TOWN OF PLAINFIELD PLAN COMMISSION

DATE: 03-05-2026
Project Page: [Crew Carwash West](#)
CASE NO.: PP-25-061
 FDP-25-61
PETITIONER: Katherine Rayner, Crew Carwash
REQUESTED ACTIONS: Architectural and Site Design Review for a proposed car wash; Amendment to existing Primary Plat
LOCATION: Ventura Boulevard at West Main Street
PARCEL SIZE: 3.74 acres +/-

PROJECT REVIEW

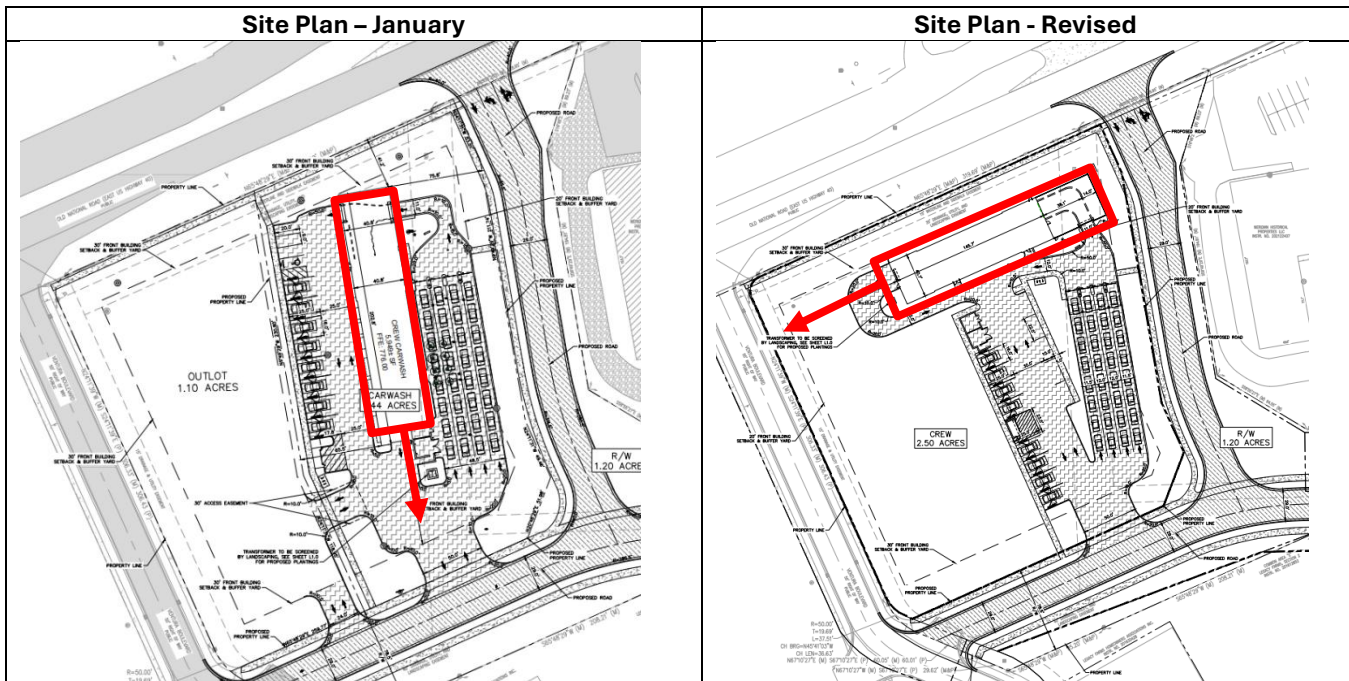
Building Orientation

The applicant has returned with a site plan that turns the building to be parallel with U.S. 40 as the Plan Commission requested. A table with the prior site plan as well as the newly submitted plan have been included below. The building footprints have been highlighted in red.

The proposed building now runs parallel to U.S. 40 with the carwash entrance located on the northeast side of the building

and the exit on the west. This orientation faces the exit dryers away from neighboring residential and towards undeveloped, commercially planned land. Additionally, the applicant has elected to retain the interior entrance tunnel for the facility, shielding vehicle's entry point into the carwash from U.S. 40 entirely.

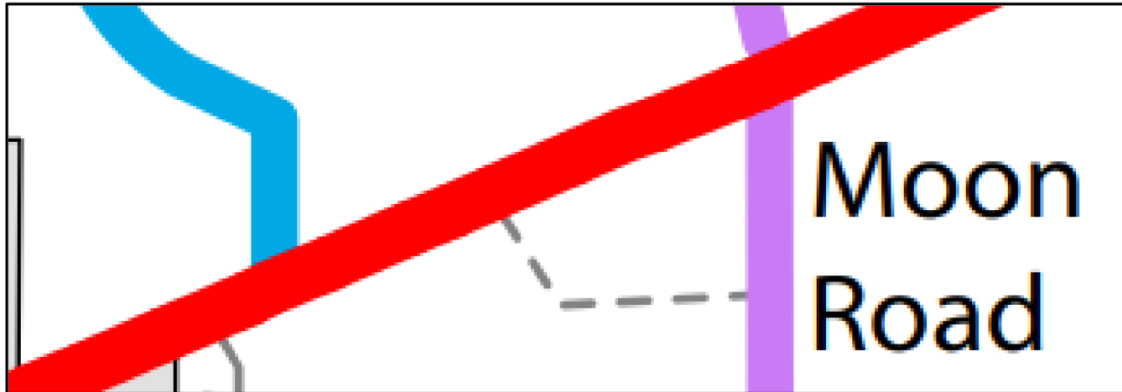
The south perimeter landscaping is of particular note. The ordinance requires more landscaping of commercially zoned properties adjacent to residentially zoned properties. Due to this, a Plant Unit Value of 12.76 is required for the south perimeter of the site. While the applicant has rotated the building as requested, that does not change the need for significant sound buffering between this property and Legacy Farms. Additionally, the applicant has not provided any landscaping along the western perimeter of the property along Ventura Boulevard.

It should also be noted that the January landscape plan proposed heavily landscaping the existing berm (shown below) as additional sound mitigation. The applicant is no longer proposing this landscaping, presumably due to the reorientation of the building. The applicant's submitted plans fall short of the required Plant Unit Value for this particular perimeter, in part due to the removal of the landscaped berm, so concern remains.
